13-AMRP-0207

**200-UP-1 GROUNDWATER OPERABLE UNIT REMEDIAL DESIGN/REMEDIAL ACTION
WORK PLAN, DOE/RL-2013-07, DRAFT B AND DRAFT TRI-PARTY AGREEMENT
CHANGE CONTROL FORM NUMBER M-16-13-01**

**U.S. Department of Energy Richland Operations Office
Responses to EPA Comments on the 200-UP-1 Groundwater Operable Unit Remedial
Design/Remedial Action Work Plan (DOE/RL-2013-07), Draft A**

Figure 1-4. 200 West P&T, Including Locations of the 200 West Groundwater Treatment Facility, and Extraction and Injection Well Systems

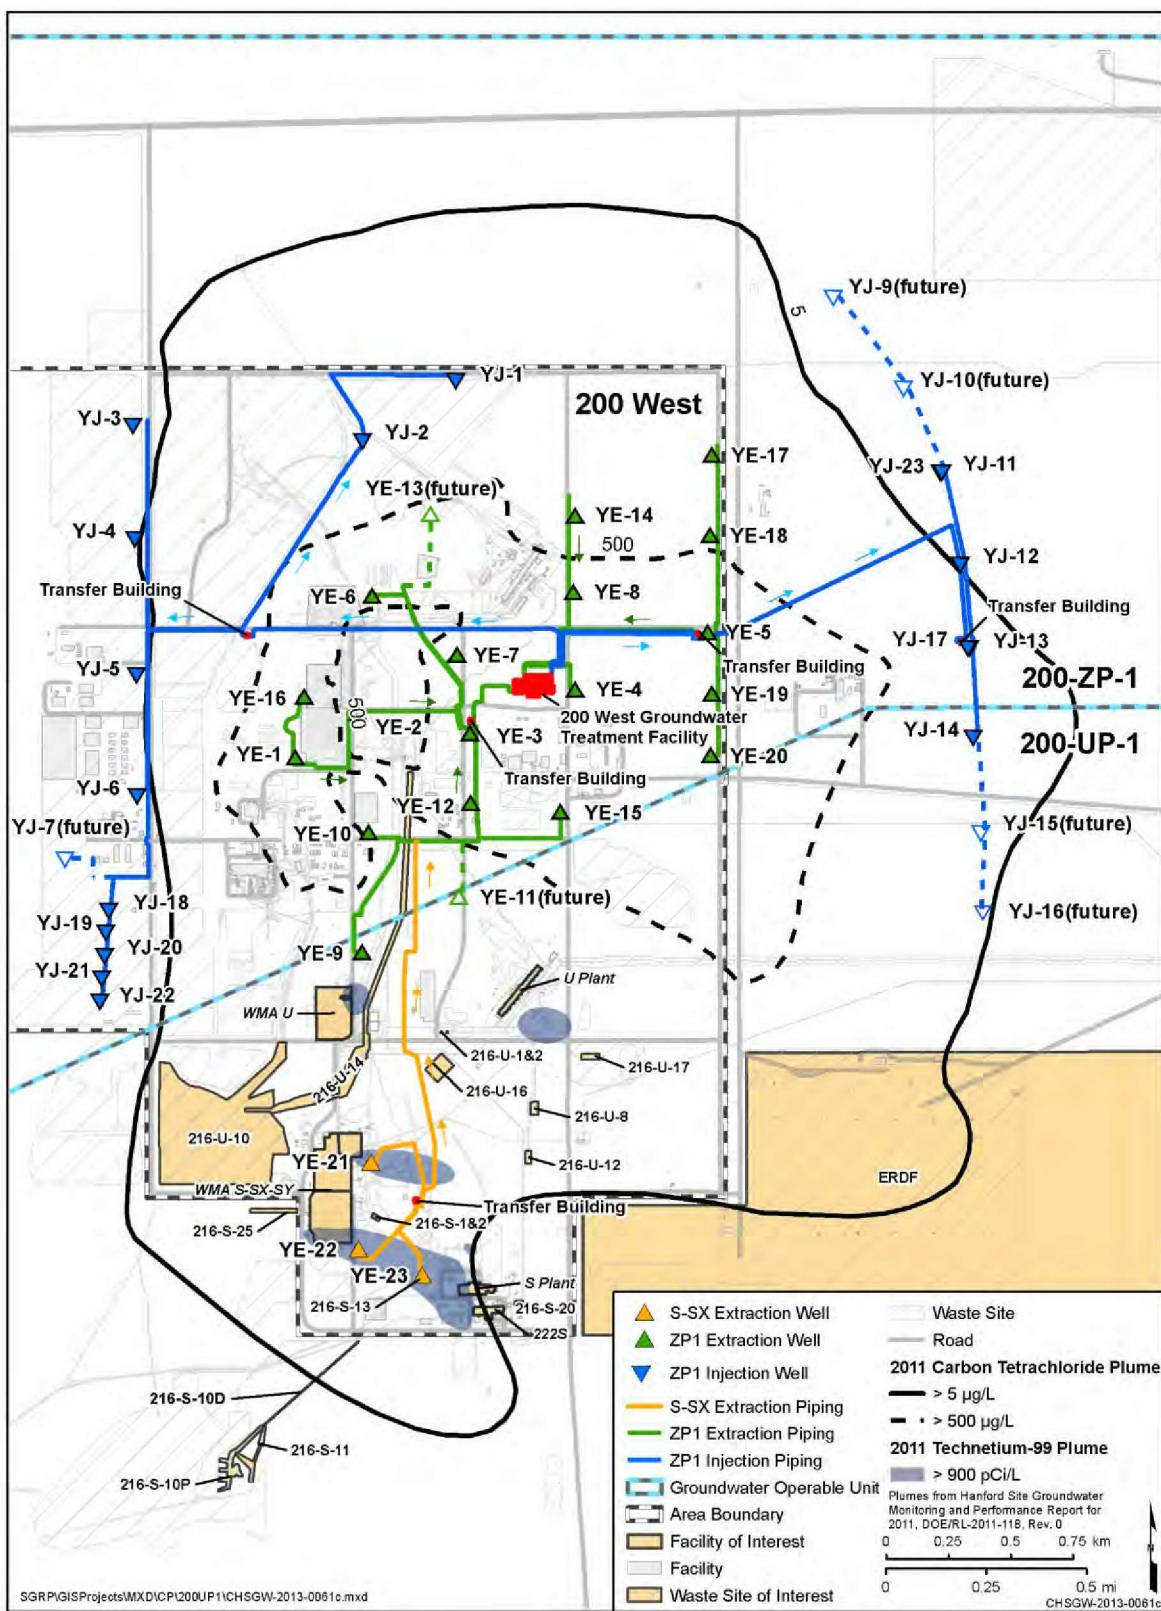
- 1) Page 1-9, Figure 1-4: Identify all the wells which have not yet been installed and hooked up on the figure more clearly. Clarify if the 2011 carbon tetrachloride plume boundary reflects points of calculation based on concentration or some regulatory changes to the RCRA point of compliance.

Response: Accept. All extraction and injection wells, actual or planned, are shown but not distinctly. The figure will be revised by enhancing the well symbols including clearly identifying which wells have not yet been installed and hooked up. The carbon tetrachloride plume boundary is based on plume published in the CY2011 annual report. The reference will be added to the figure.

Figure 3-4. Conceptual Layout of Transfer Pipelines, Transfer Buildings, and Associated Extraction and Injection Wells for the 200-UP-1 OU Remedy

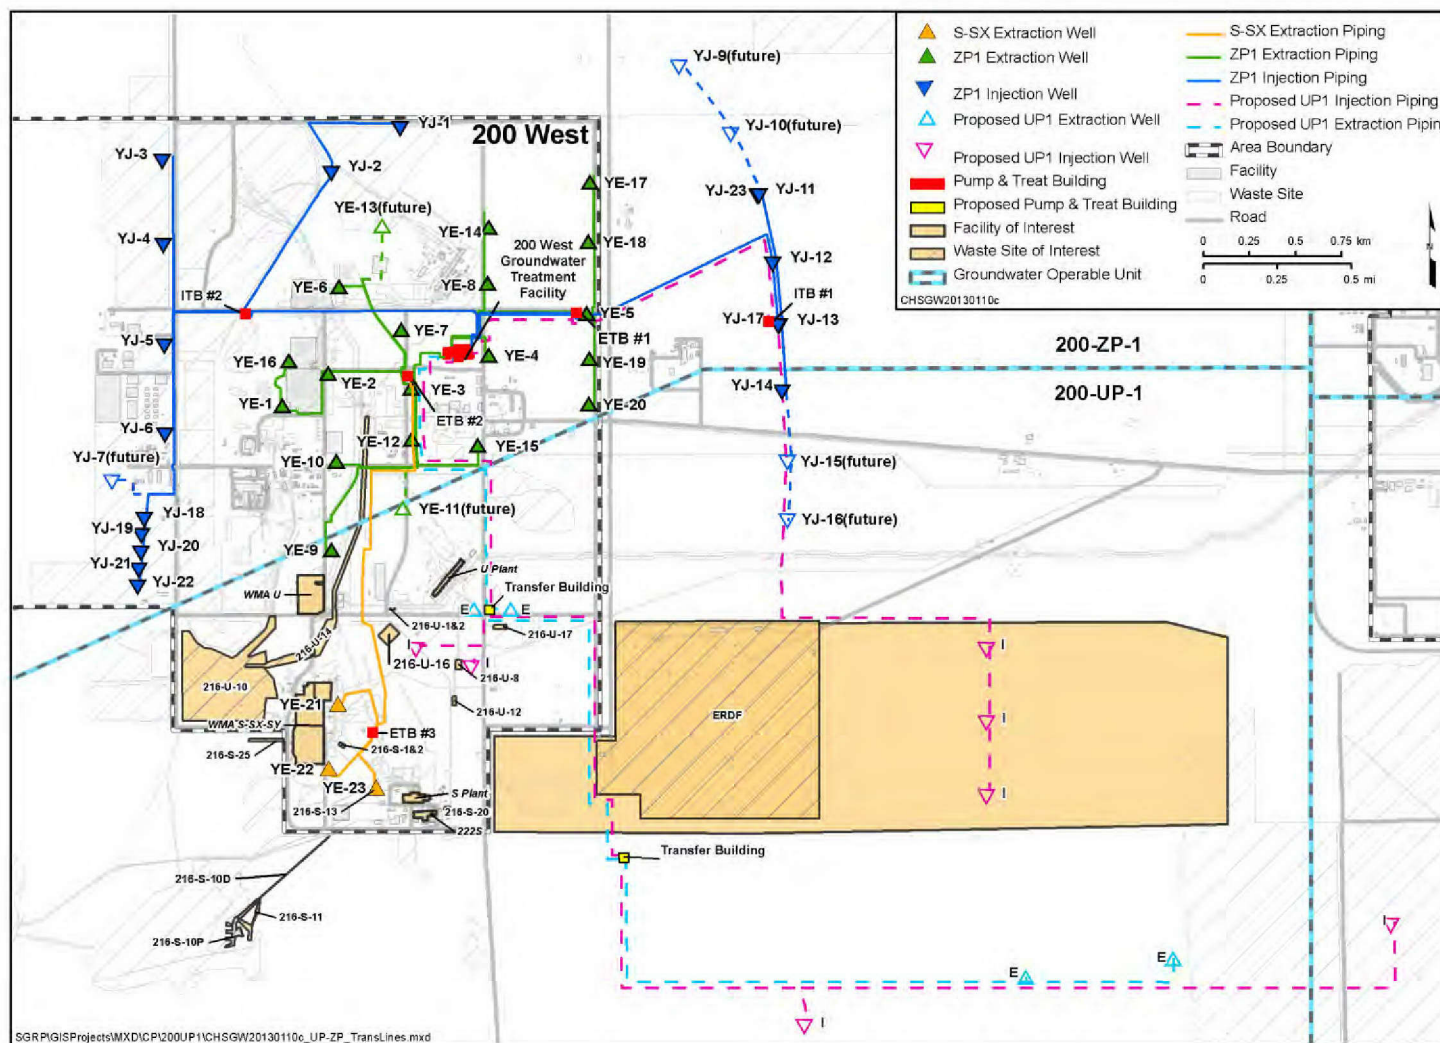
- 11) Page 3-17, Figure 3-4: Identify all the wells which have not yet been installed and hooked up on the figure more clearly. Clarify why the area around ERDF is labeled as a “facility of interest.”

Response: Accept clarifying Figure 3-4 (see disposition to comment 1). The ERDF is a facility discussed in the text and is shown in the Figure accordingly.

Figure 7-1. 200-UP-1 OU Remedy Implementation Schedule

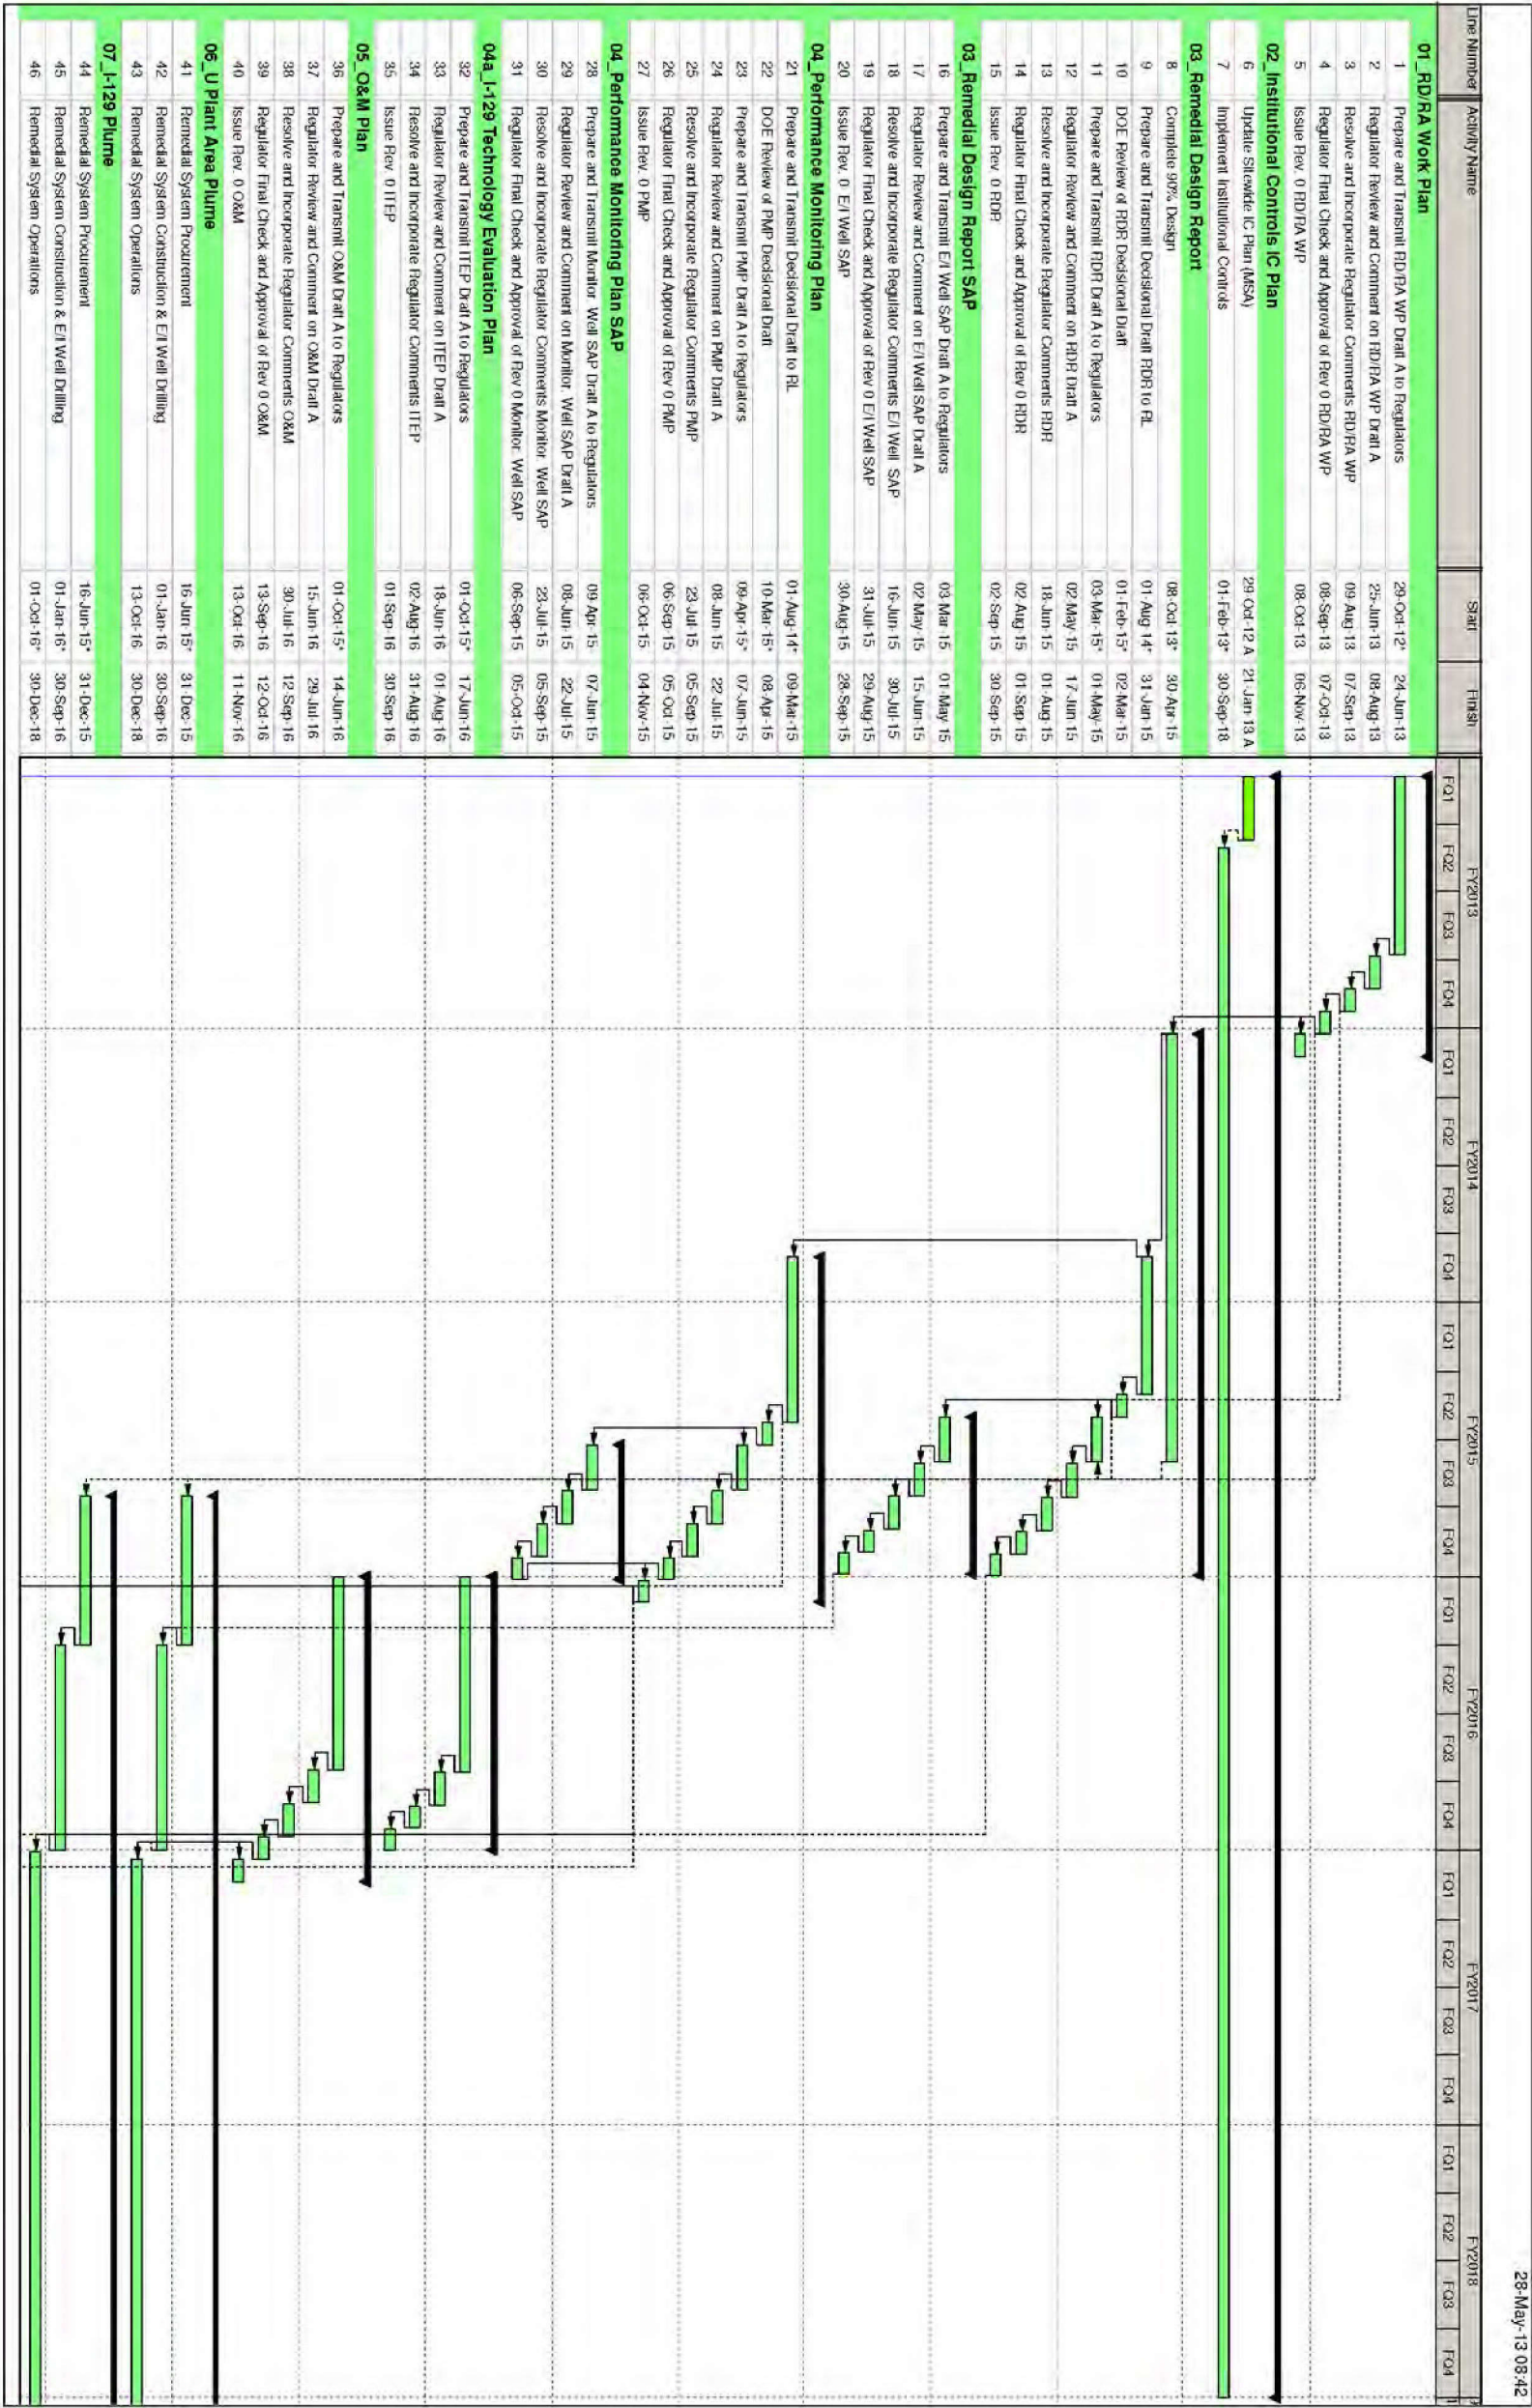
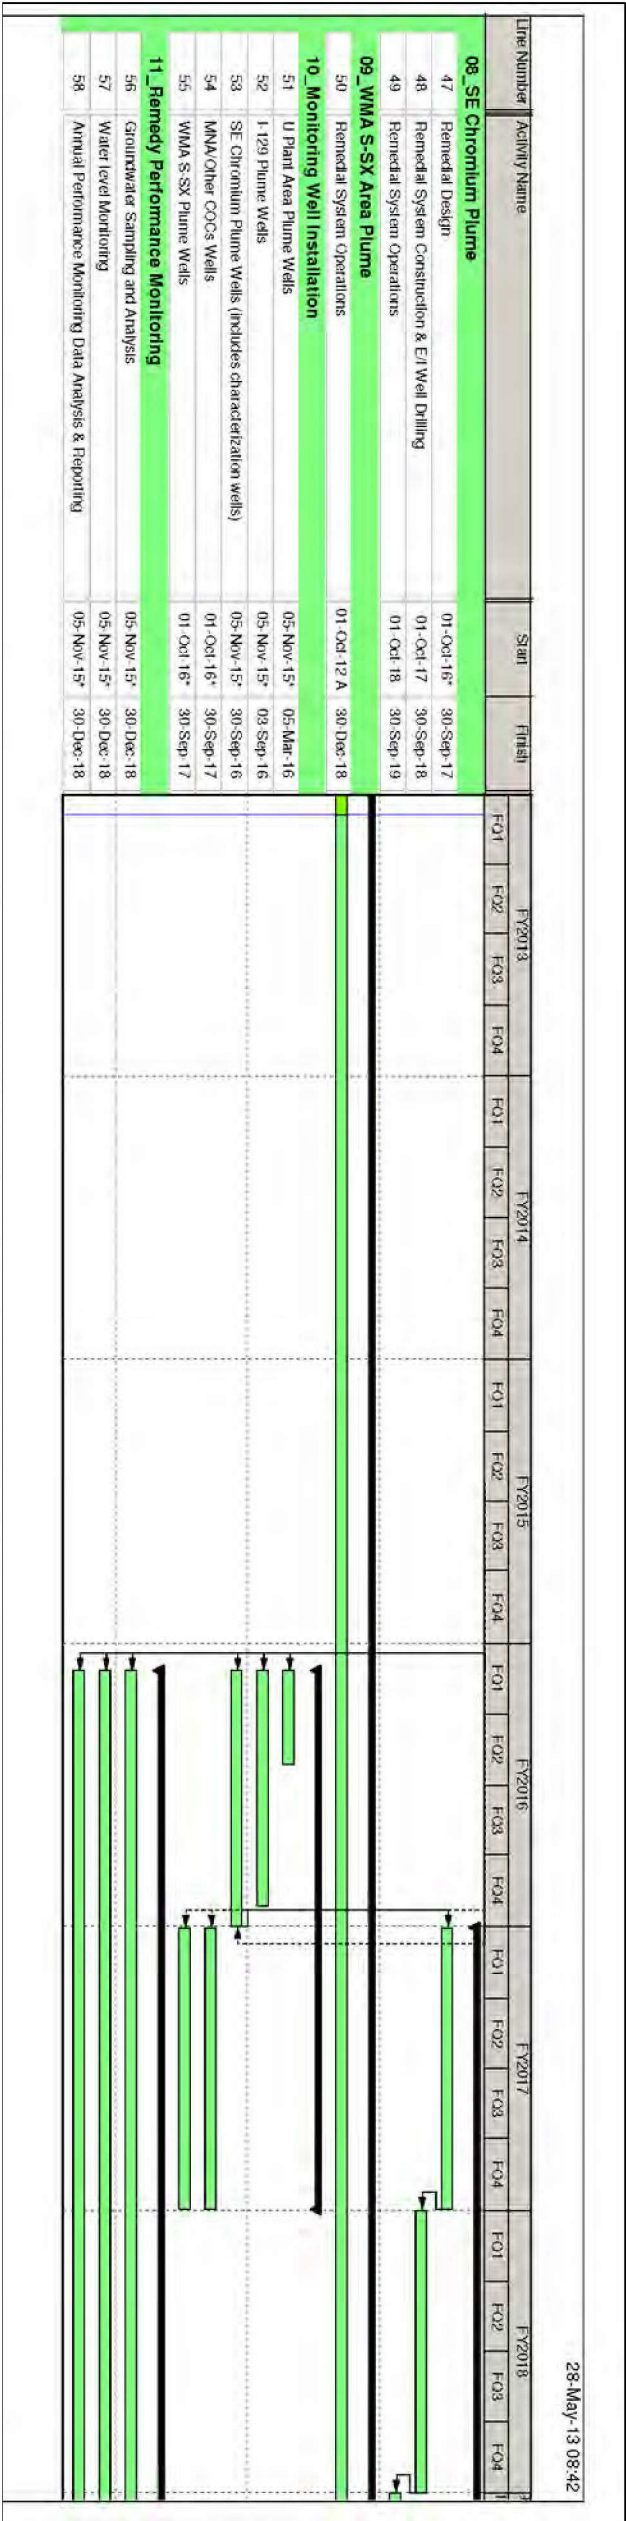
- 5) Page 2-12, Section 2.4: The schedule for the SAP for monitoring well installation should be included in the implementation schedule in Figure 7-1. This SAP should be considered part of the work plan.

- 21) Page 7-4, Figure 7-1: EPA is highly concerned with the remedy implementation schedule proposed in the document which would delay all well installation of the pump-and-treat remedy component

until fiscal year (FY) 2016 through FY 2018. Remediation of groundwater at the Hanford Site is a top priority for EPA. EPA's expectation for the 200-UP-1 OU remedy is that all wells will be drilled in FY 2014 through FY 2015 and all wells will be connected to the 200 West Pump-and-Treat facility by FY 2016. Revise the implementation schedule accordingly.

Response: Accept, the SAP for monitoring well installation will be added to the Figure 7-1 schedule.

Response: The last sentence in the section says “results of the DQO process will be documented in a SAP as part of the PMP.” The SAP activity will be added to the Figure 7-1 schedule.

Extraction/injection wells will be drilled under the Remedy System Construction activities (28, 32, and 35) in Figure 7-1. This will be clarified in Section 4.3.3 Construction. With regard to monitoring wells, Figure 7-1 shows separate activities (38-42), by plume area, for drilling the monitoring wells. Line 40 will be clarified that the SE Chromium Plume wells includes the characterization wells. No change to the timing of well drilling, which is based on current DOE budget constraints. The completion of the associated groundwater transfer lines and infrastructure needed to remediate the SE chromium plume would be performed under activity 35 in Figure 7-1 and as discussed in Section 4.3.3 Construction.

Response:

d) The start and completion dates for any SAPs associated with the 200-UP-1 remedy will be added to the schedule.
